## **IFB ADDENDUM #2**

Re: IFB 2023-10 City View Towers Electrical Upgrade

This Addendum modifies and forms a part of the Bid Set documents dated December 13, 2023.

PARTIAL ONE LINE DIAGRAM  
NEW WORK

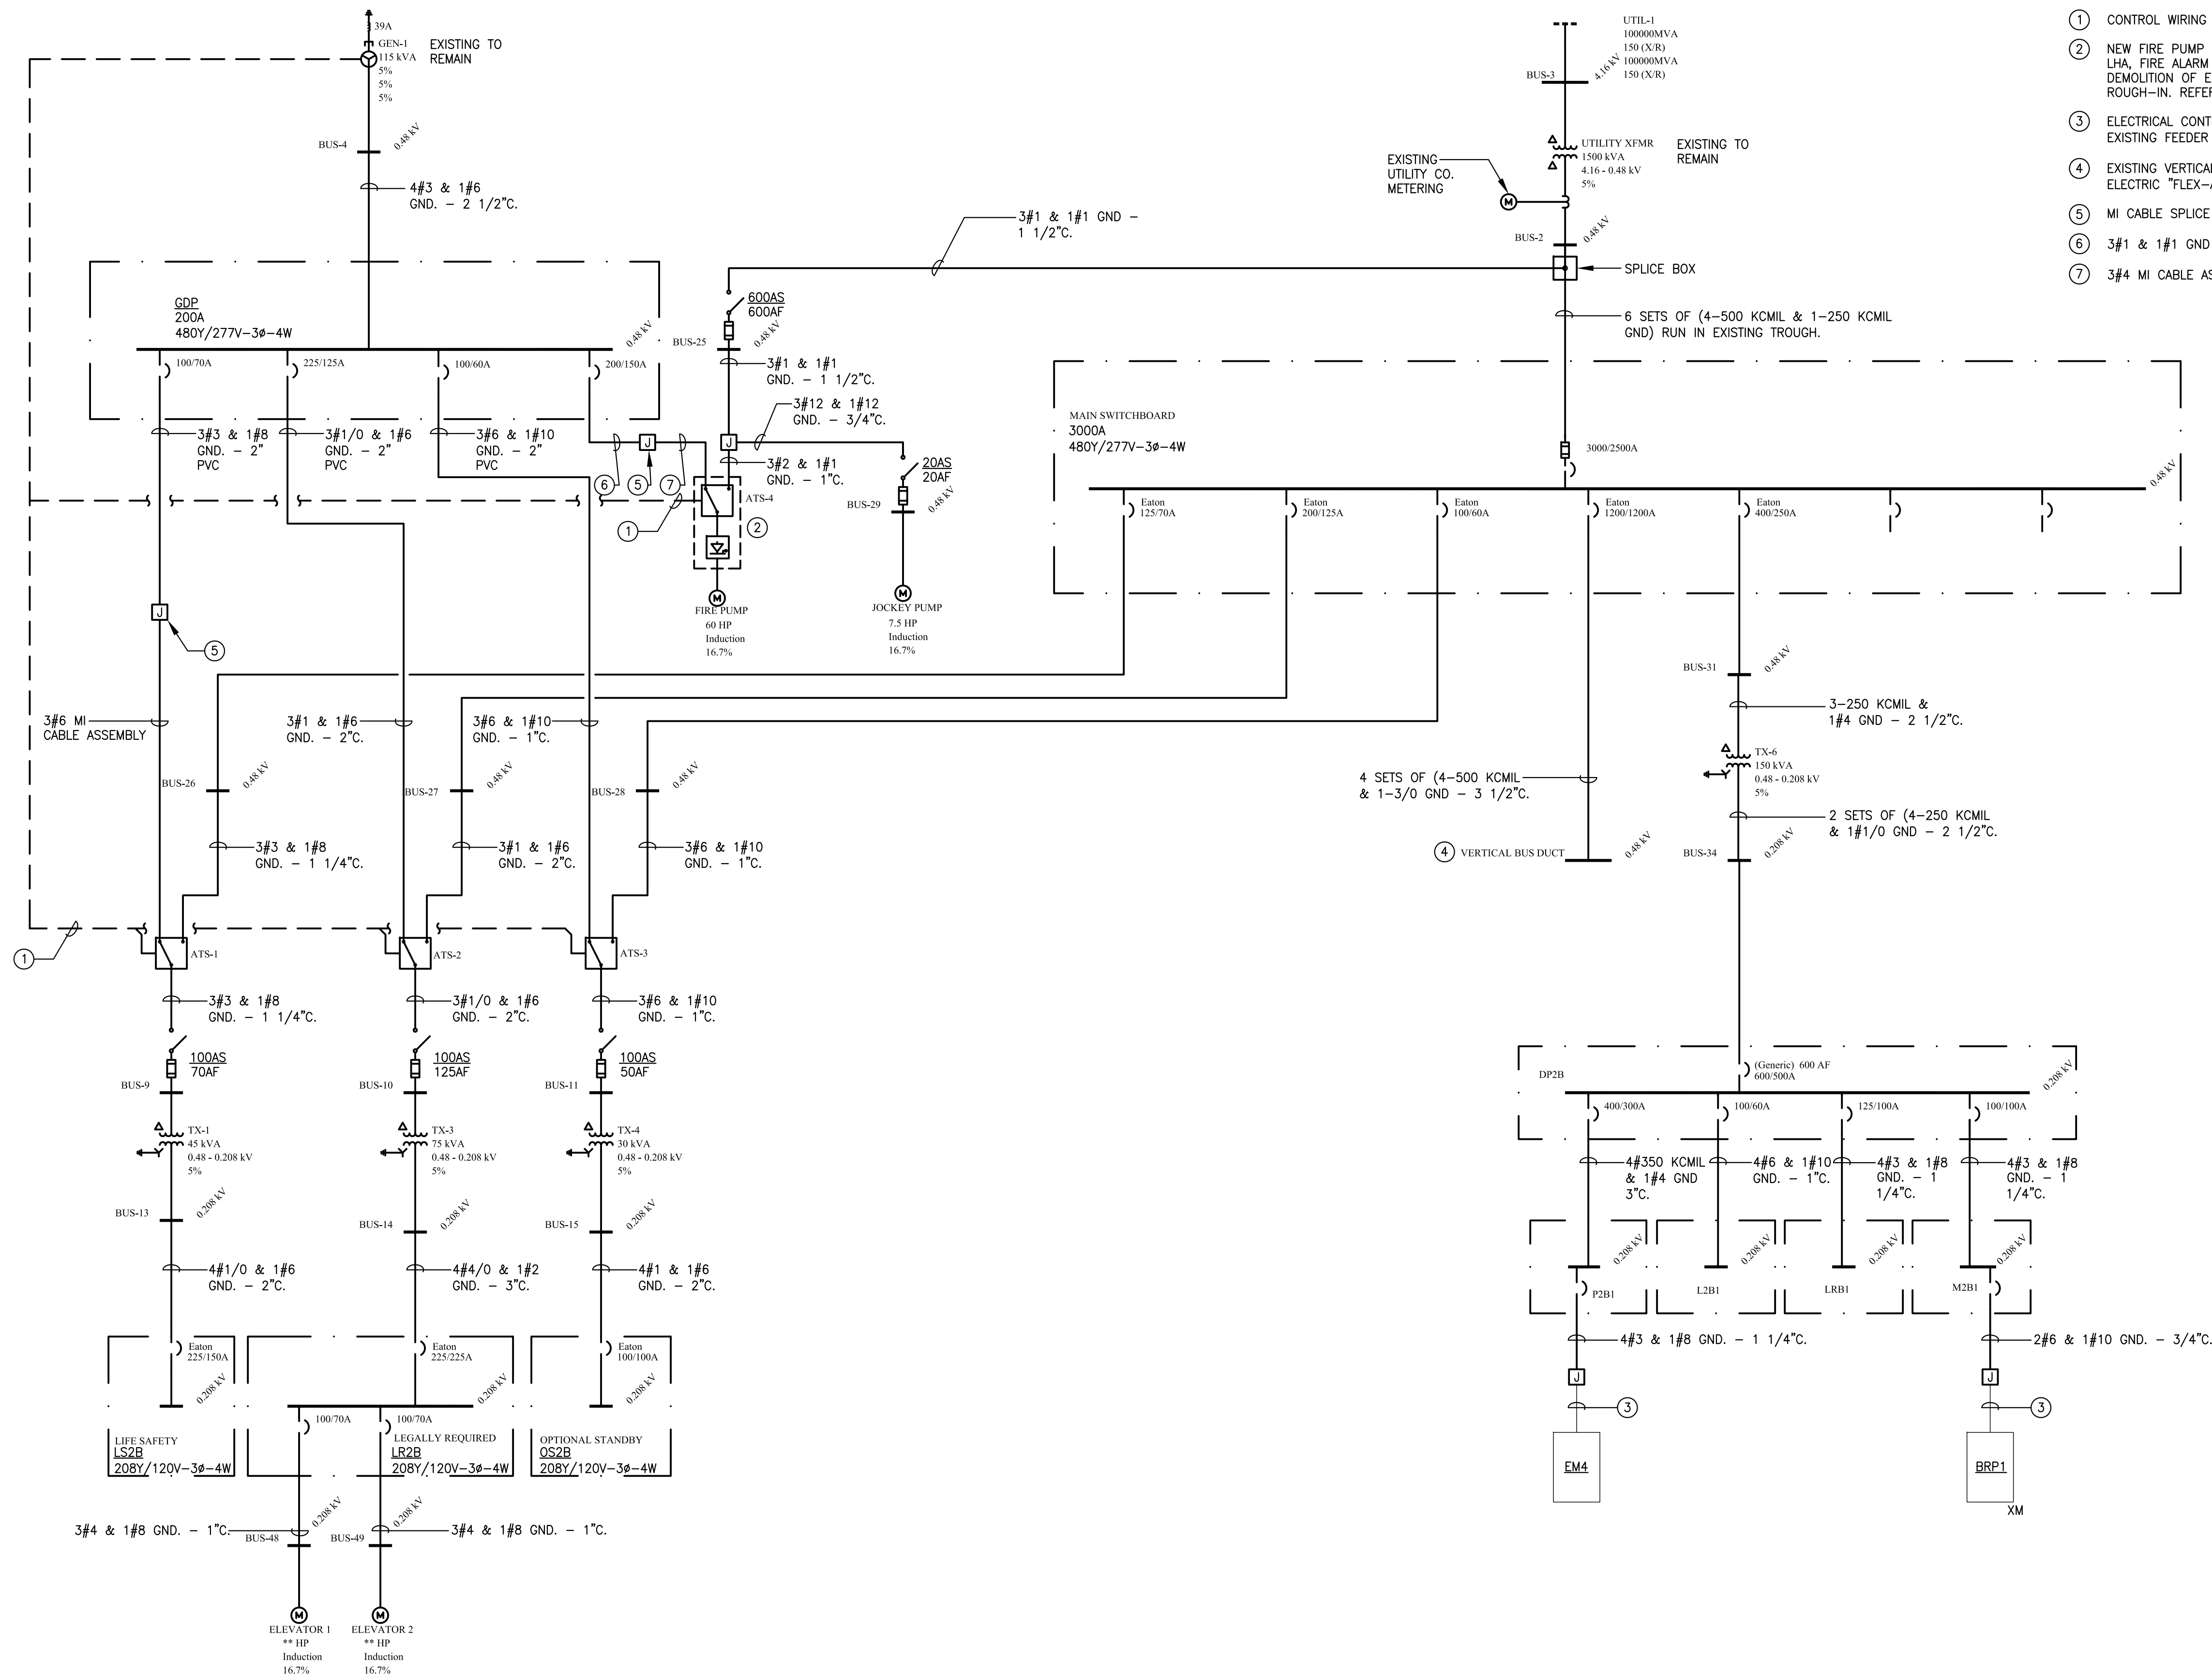
#### **Drawing E7.02 - One Line Diagram - New Work**

1. Delete drawing in its entirety and replace with revised Drawing.
